MIL-M-28787/61B
AMENDMENT 2
31 December 1992
SUPERSEDING
AMENDMENT 1
13 September 1985

MODULES, STANDARD ELECTRONIC

FLIP-FLOP, D TYPE, DIGITAL, KEY CODE KDR

FIGURE 22. Threshold clock test circuit waveforms for table XVI.

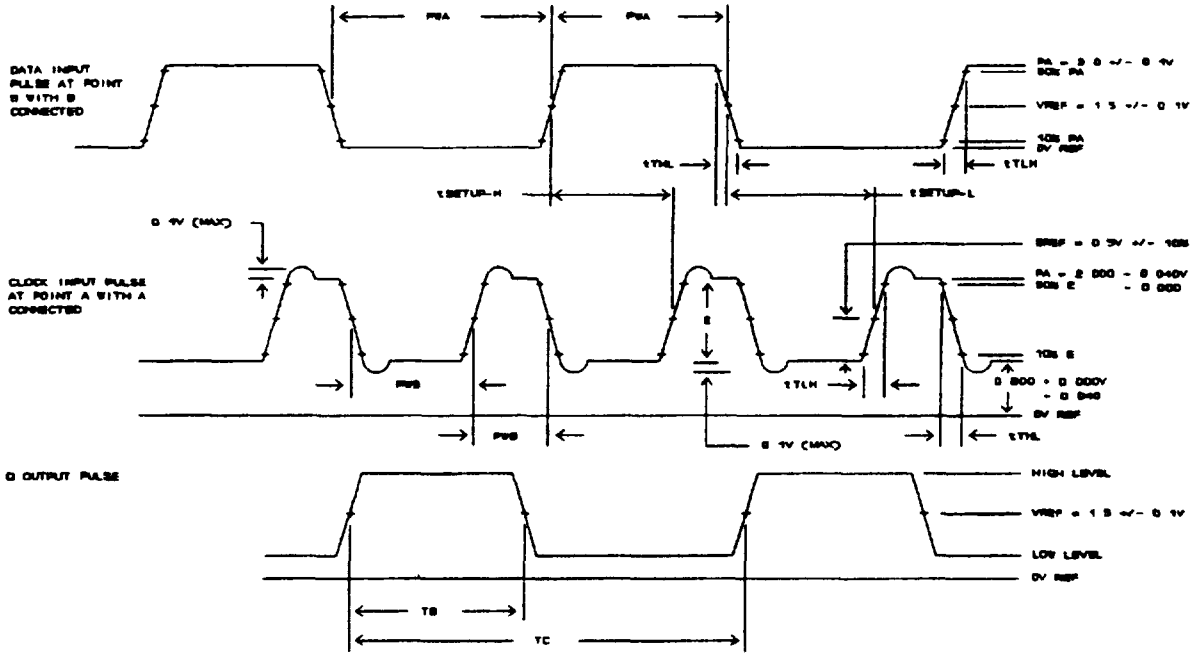
FIGURE 22: Delete and substitute new figure 22 as printed on page 3 of this amendment.

1. Input pulse parameters:
   PWA = 500 ns ± 10%.
   PWB = 250 ns ± 10%.
   tTLH = tTHL = 25 ns ± 10%.
   tSETUP-H = tSETUP-L = 125 ns ± 10%.
2. Both outputs of the circuit under test shall be loaded simultaneously.
3. Parameters TB and TC as measured on item D05 shall comply with electrical requirements of test conditions U1-U6 and shall be measured per waveforms above. Before making these measurements, the output levels shall be verified to be $\leq$ 0.4 V for the low level and $\geq$ 2.4 V for the high level.

FIGURE 28. Power supply transient amplitude test circuit waveforms for table XX.

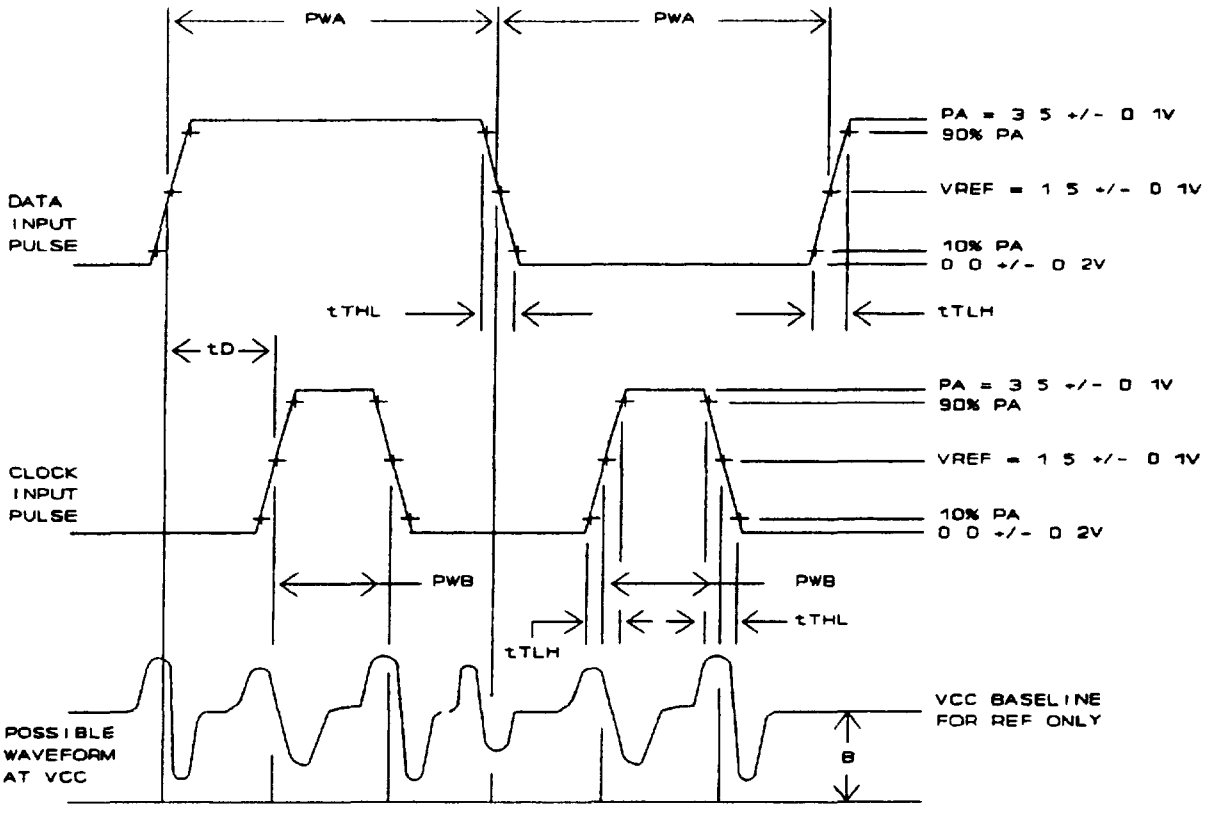
FIGURE 28: Delete and substitute new figure 28 as printed on page 4 of this amendment.

1. Input pulse parameters:
   PWA = 500 ns ± 10%.
   PWB = 100 ns ± 10%.
   PRR (Clock) = 2 MHz ± 10%.
   tTLH = tTHL = 10 ± 1 ns.
   tD = 200 ns ± 10%.
2. Connect point A as close as possible to pin 1 on the module. Observe power supply transient on item D05; typical waveforms are shown above.
3. B = measurement from the baseline to the most negative excursion of the waveform.
